**SECTION 00 90 01
BIDDING AND CONTRACT REQUIREMENTS
ADDENDUM NUMBER 1**

Issued: October 30, 2024

Re: ADDENDUM NUMBER (1) TO THE BIDDING DOCUMENTS FOR

**McHenry County College
2024 Renovations – Bid Package 2**
Architect's Project Number: 24-013

ED1.20

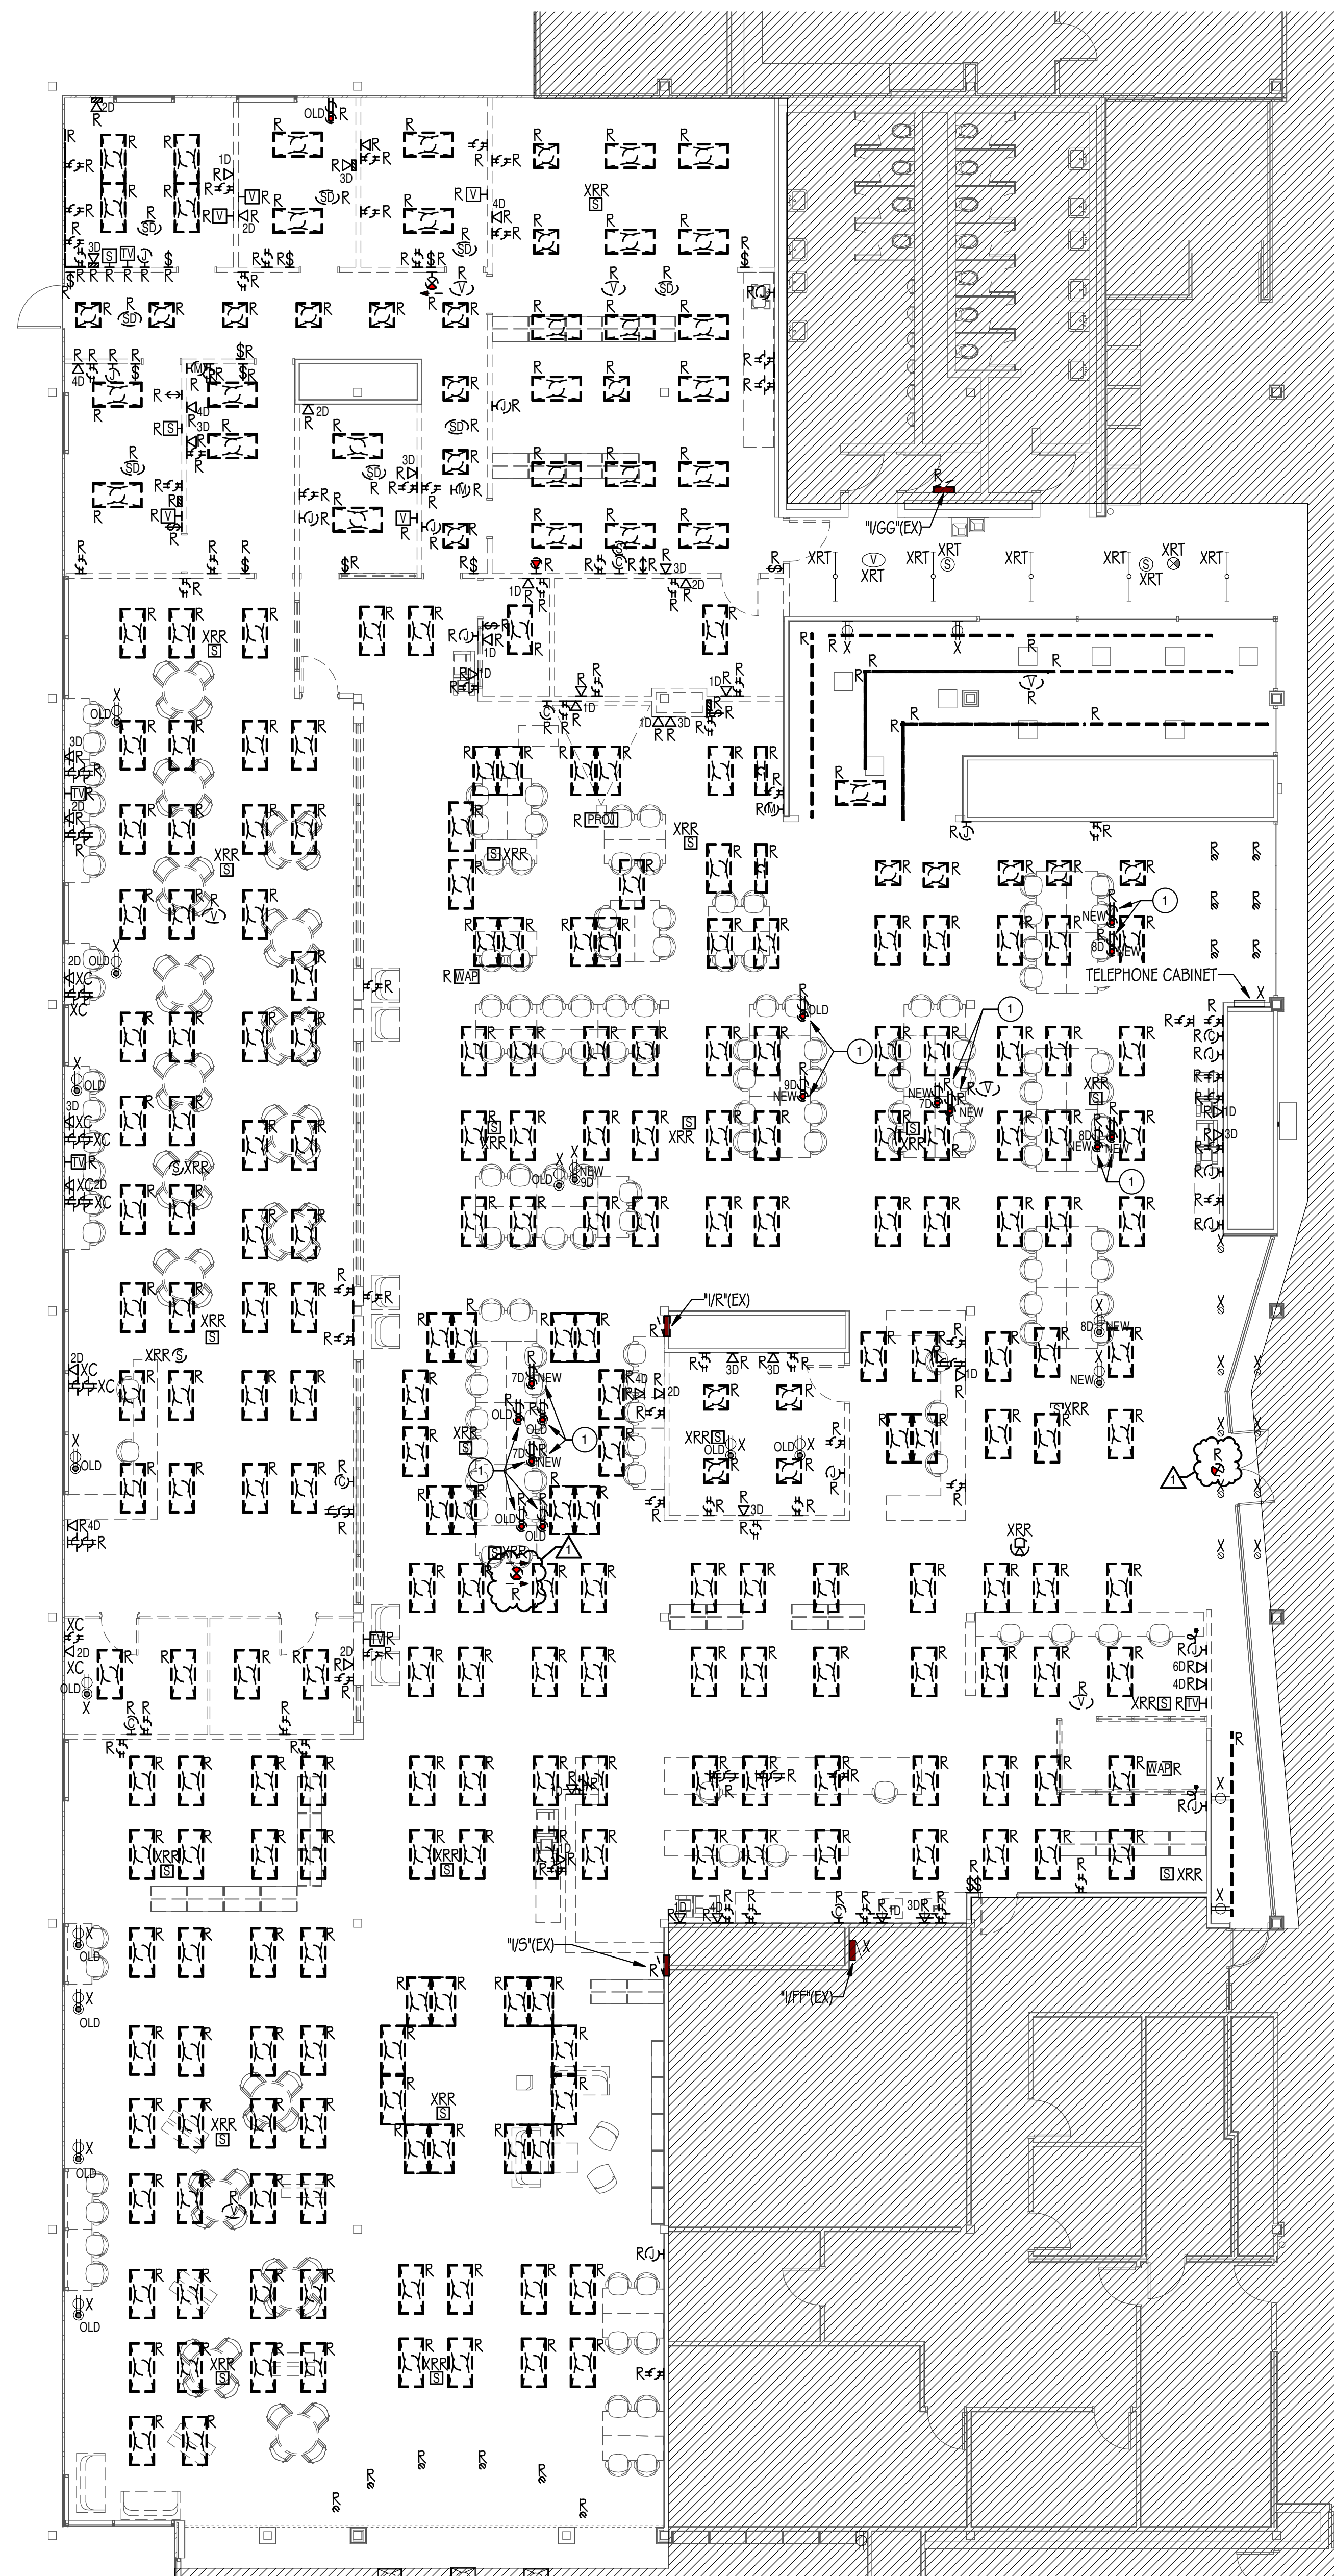
1. ED1.20
 - A. **REVISE** demolition tag for exit sign at (2) locations.
2. E1.20
 - A. **DELETE** electric door strike at glass door to Tutoring A212K.
 - B. **ADD** magnetic lock and associated drawing note at glass door to Tutoring A212K.

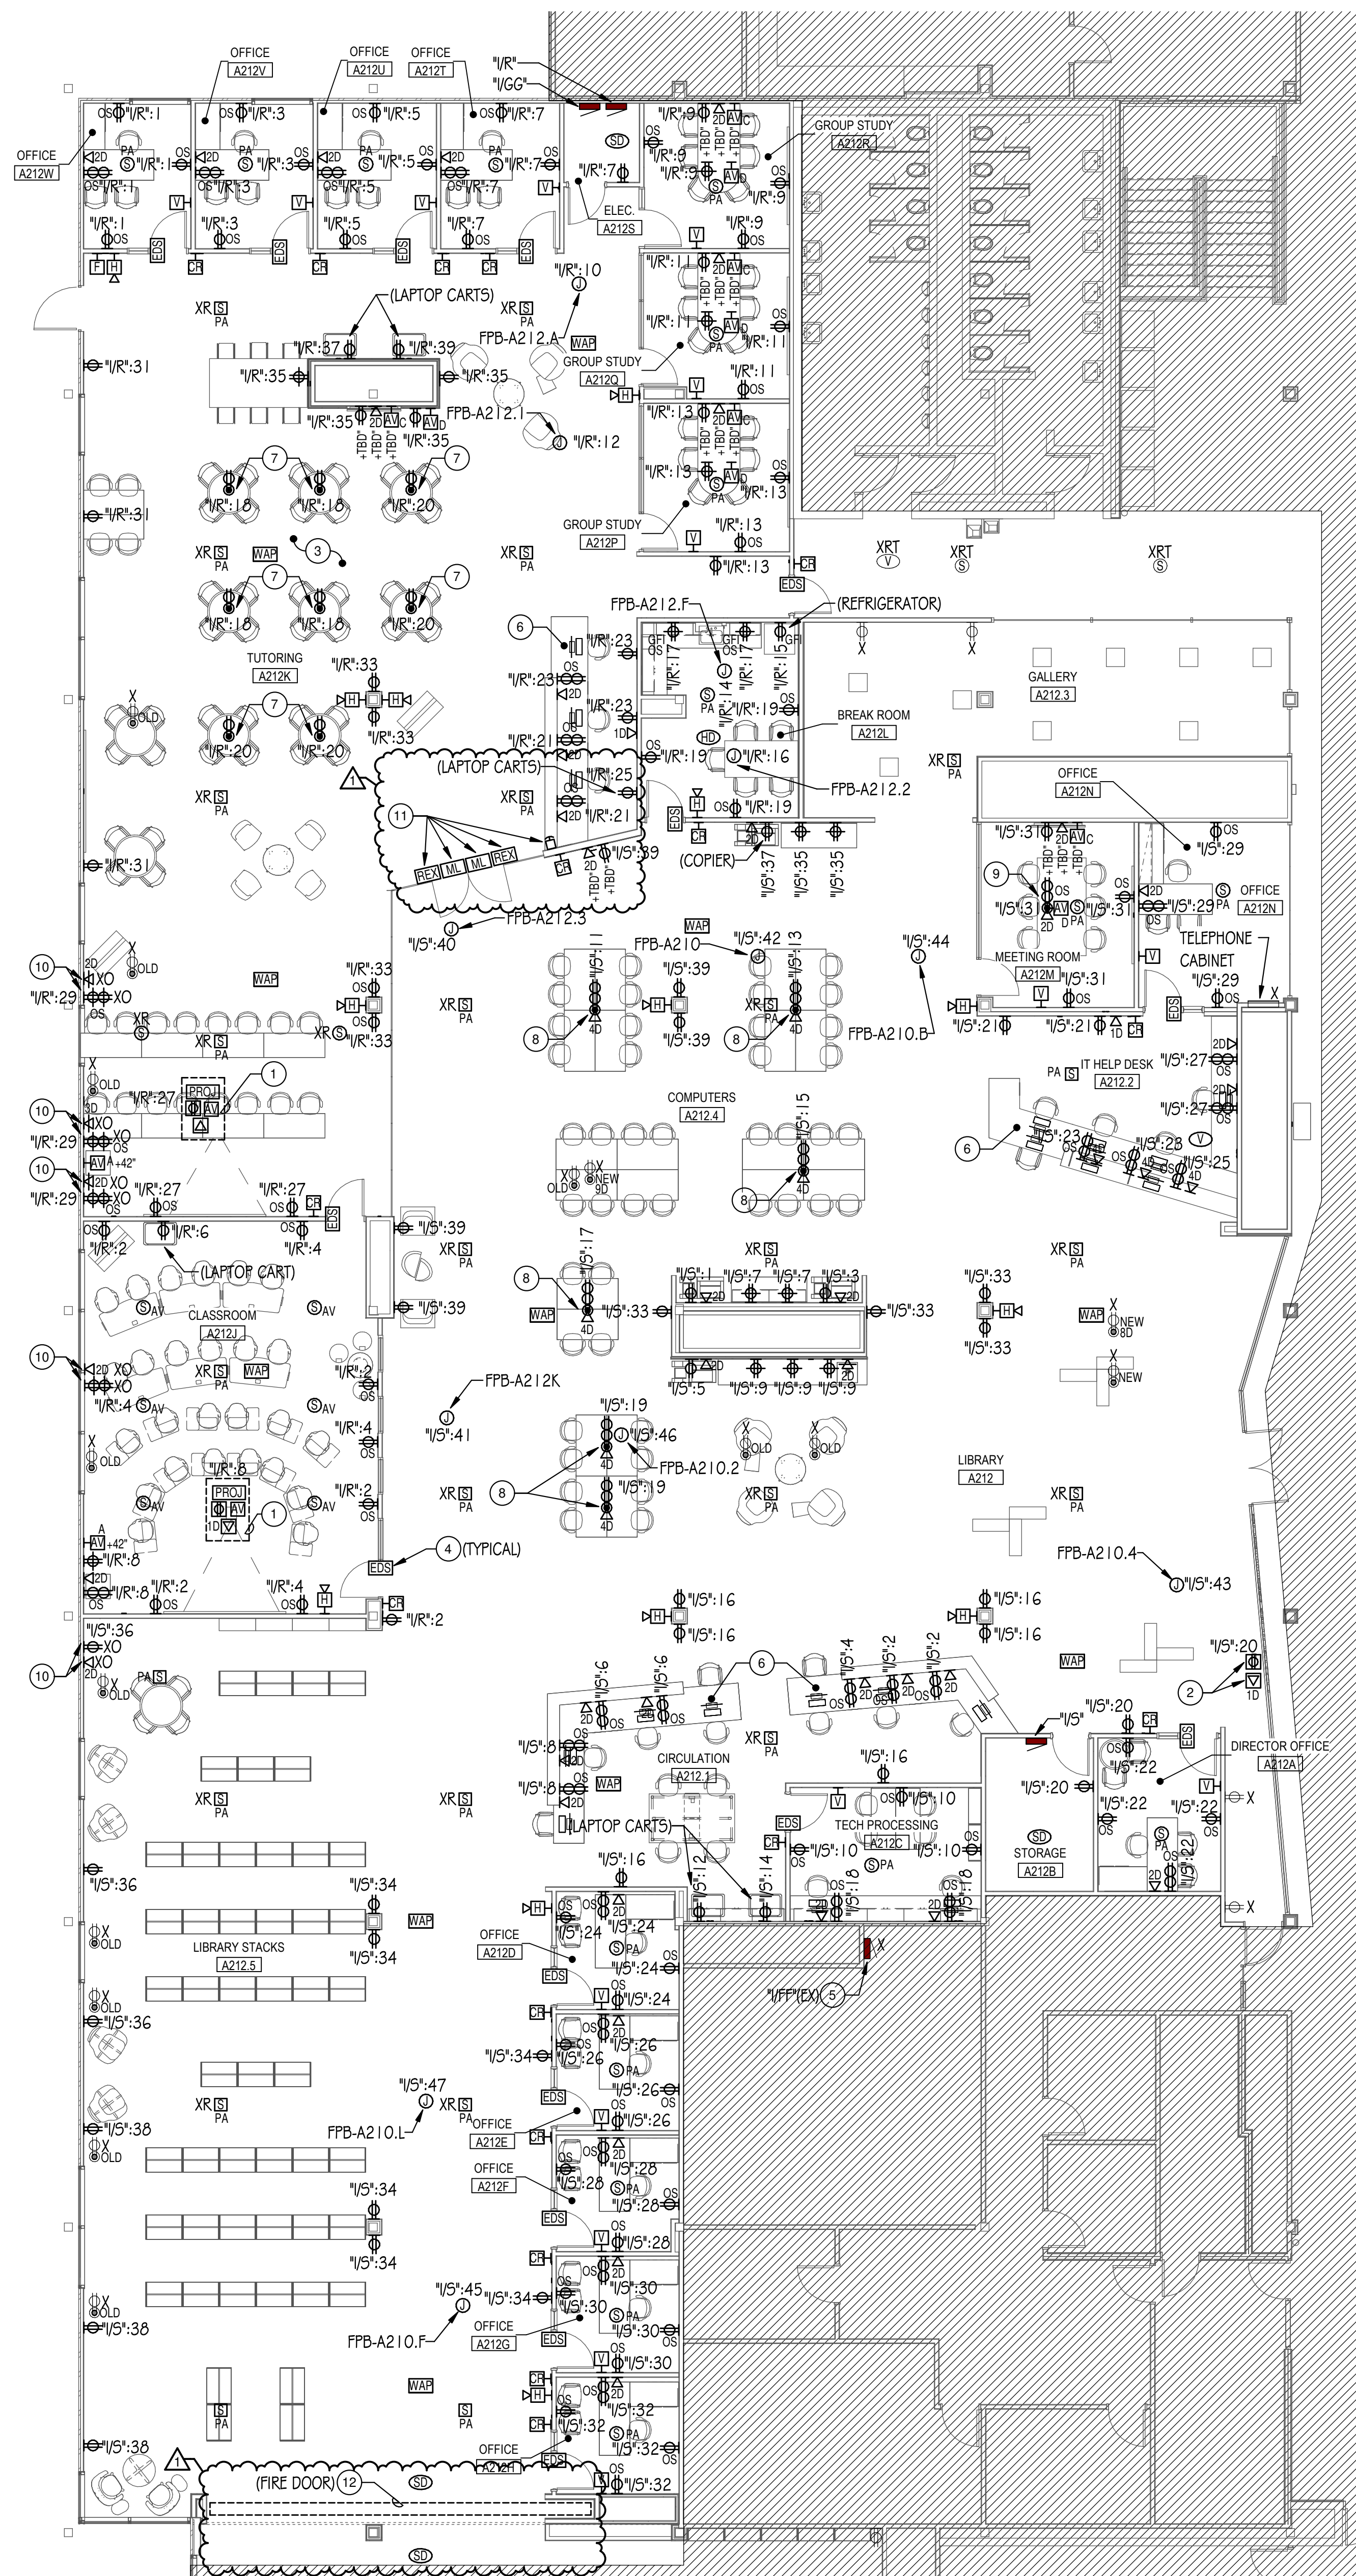
- C. **ADD** fire door and associated note in Library Stacks A212.5.
3. E2.11
 - A. **REVISE** luminaire type in Office D166A, Office D166B, Storage D151A.

E2.20

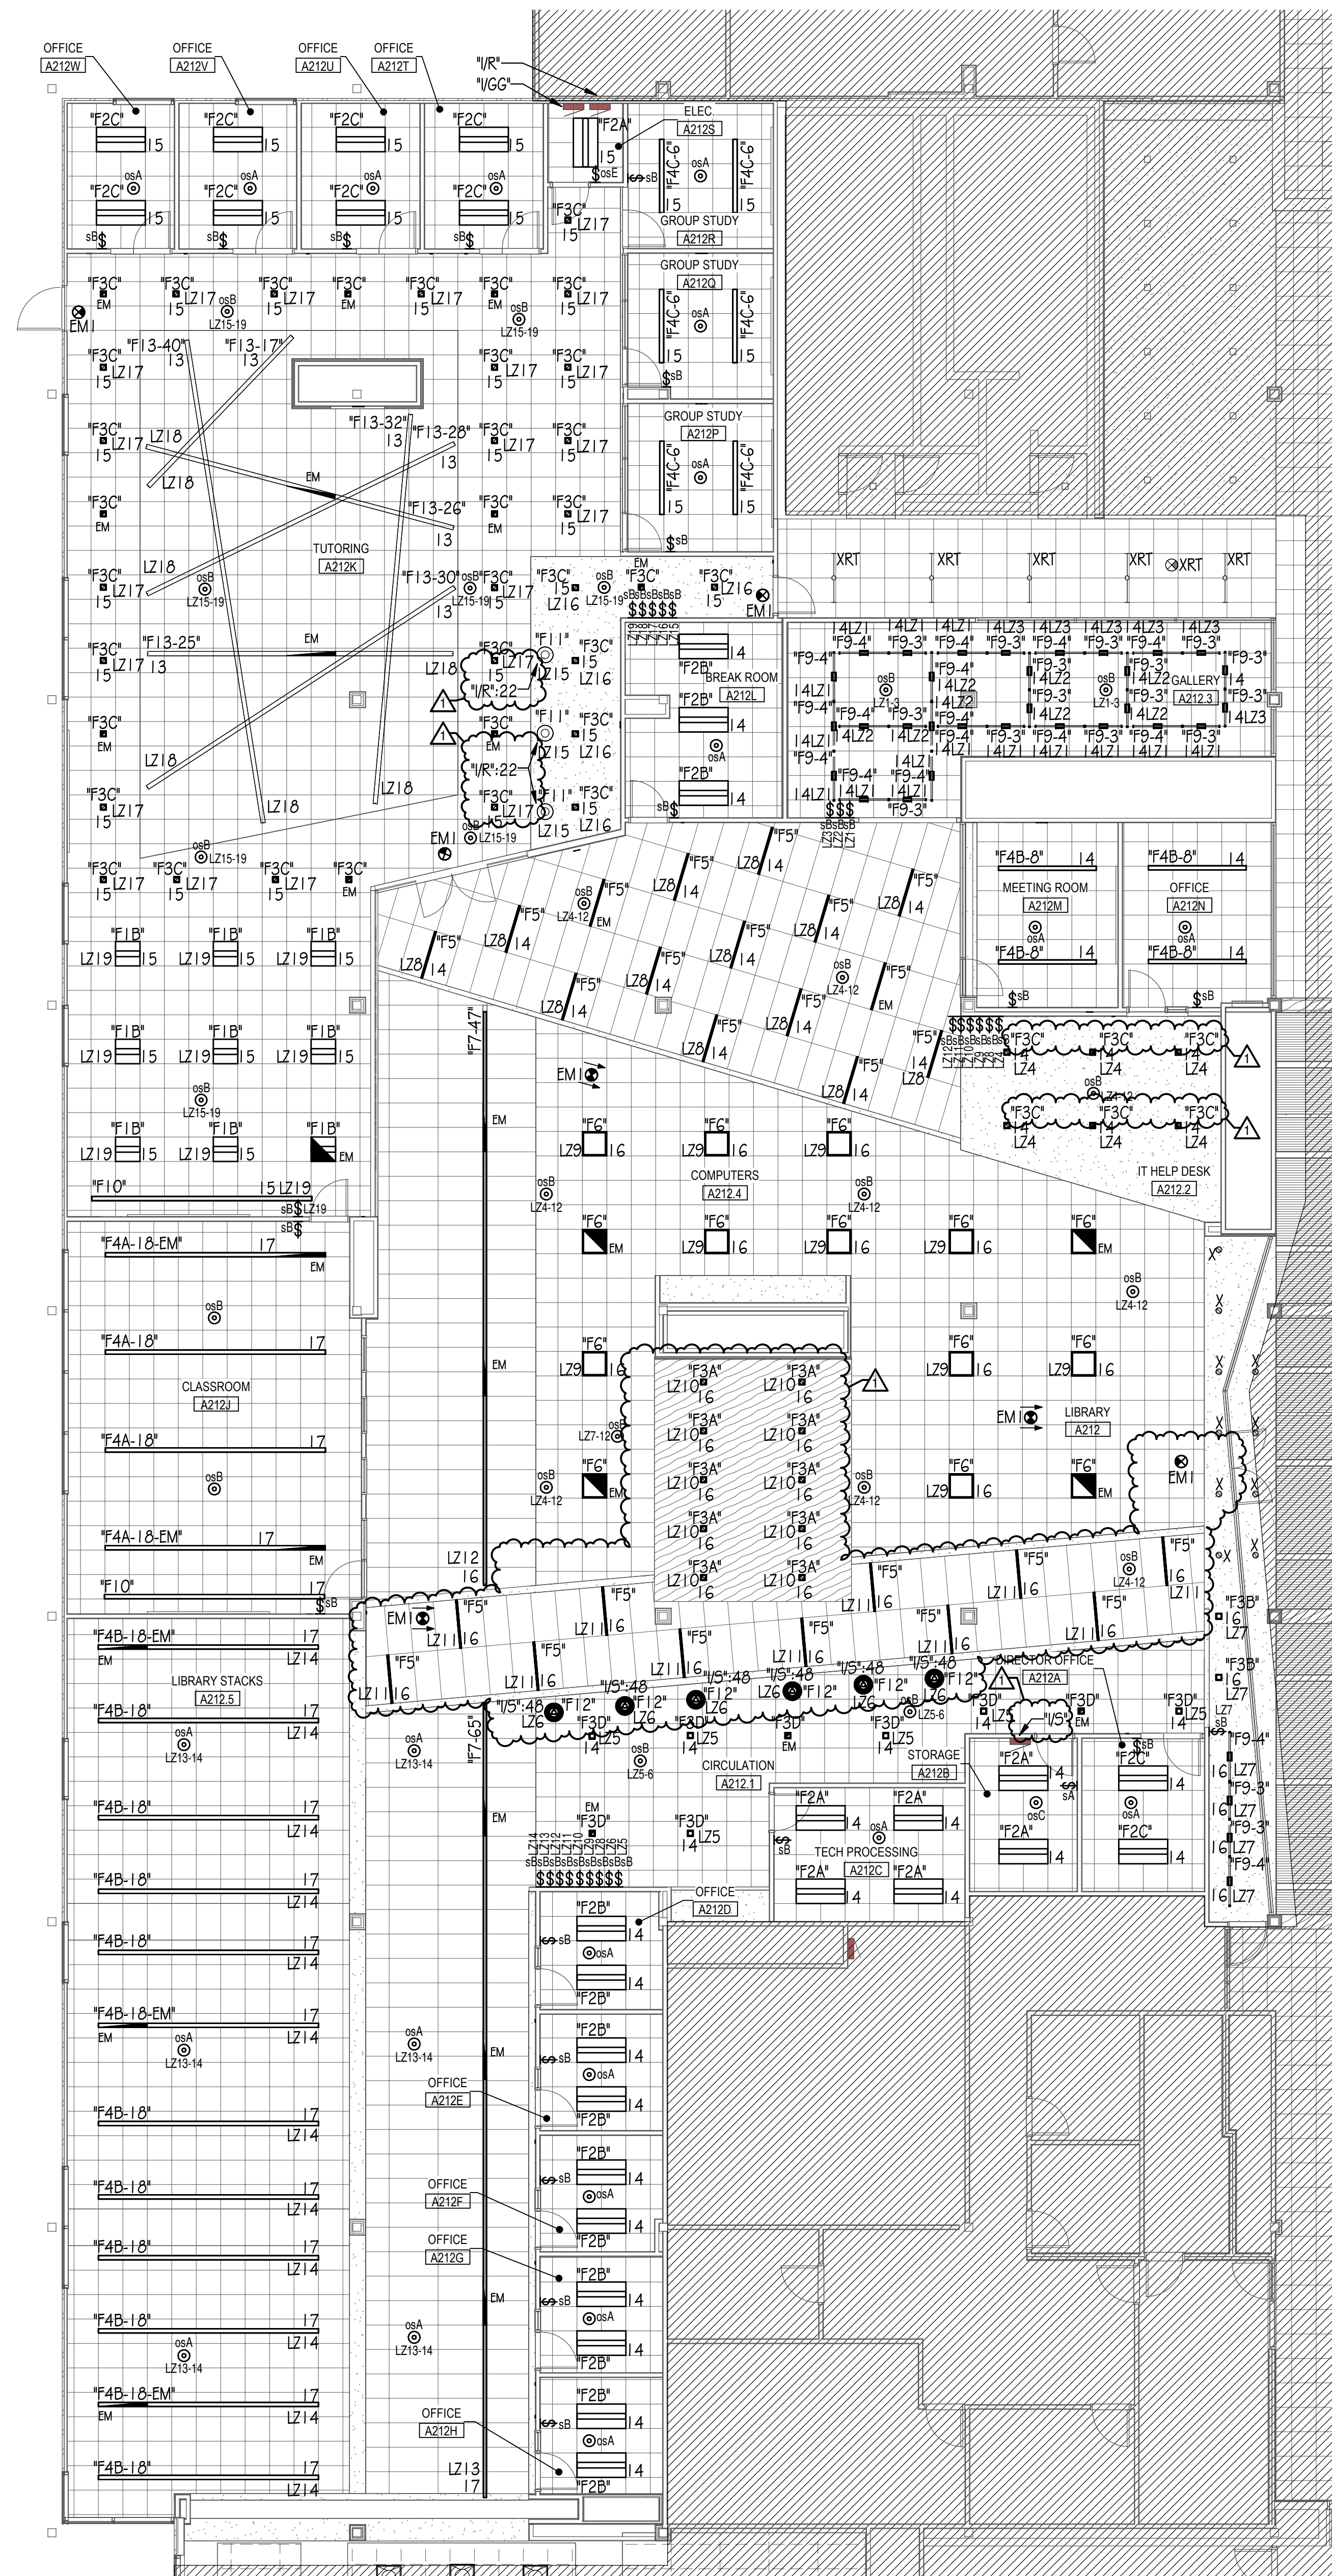
- B. **REVISE** drawing note #1 in Office D166A, Office D166B, Mock Apartment Bedroom D167B.1, Mock Apartment Bathroom D167B.2.
4. E2.20
 - A. **ADD** circuiting to luminaire type "F11" in Tutoring A212K.

- B. **REVISE** luminaire type in Library A212 and IT Help Desk A212.2.
 - C. **REVISE** circuiting to luminaire type "F11" in Circulation A212.1.
 - D. **REVISE** exit signs in Library A212.

- E. **ADD** panel tag in Storage A212B.
5. E4.00
 - A. **REVISE** 'LUMINAIRE SCHEDULE' as indicated.
 - B. **DELETE** luminaire type "F1C", "F3", "F4A-12", "F5A" from 'LUMINAIRE SCHEDULE'.
